SUBJECT: FORWARDS RESPONSES TO ROUND ONE, SET THREE QUESTIONS FROM
 AUXILIARY SYS BRANCH. RESPONSES WILL BE INCORPORATED IN FSAR.

Subject: WPPSS NUCLEAR PROJECT NO. 2
RESPONSES TO ROUND ONE
QUESTIONS, SET THREE - ASB

Auxiliary Systems Branch Questions
(10.10 - 10.34)

FIGURE
9.2-8

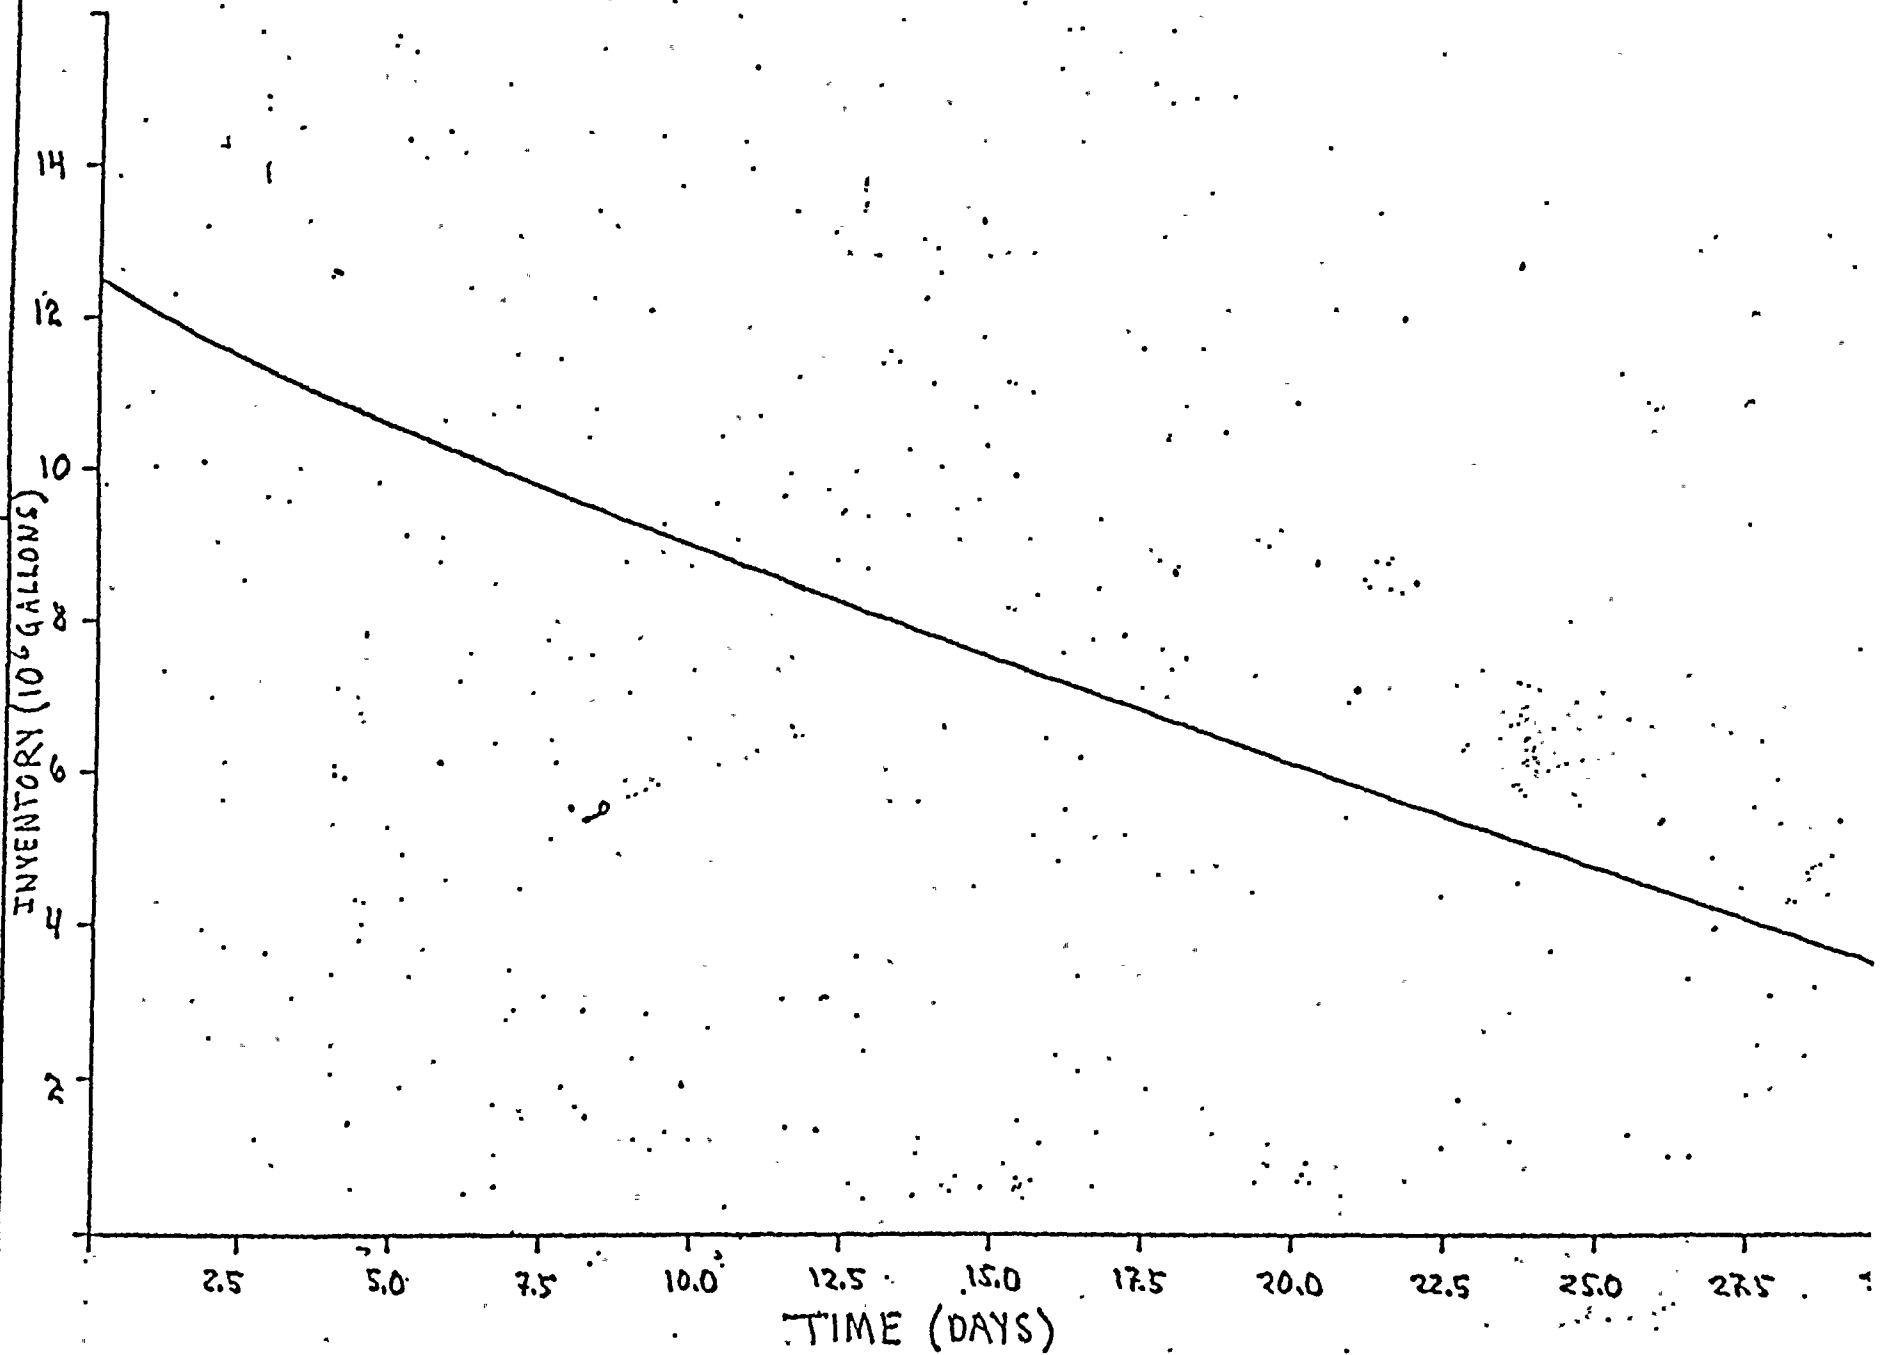
Provide the results of your analysis of the capability of the ultimate heat sink to absorb heat over a thirty-day period following a postulated design basis accident. Indicate the total heat absorbed in the ultimate heat sink, including the sensible heat, the station auxiliary system heat, and the decay heat released by the reactor core. In particular, provide the following information in both tabular and graphical formats:

The results of the mass loss analysis assuming an unfouled heat exchanger is shown in Figure 9.2-8 and is tabulated in Table 9.2-3. The mass loss assuming a fouled heat exchanger is less severe, but only by approximately 2,000 gallons.
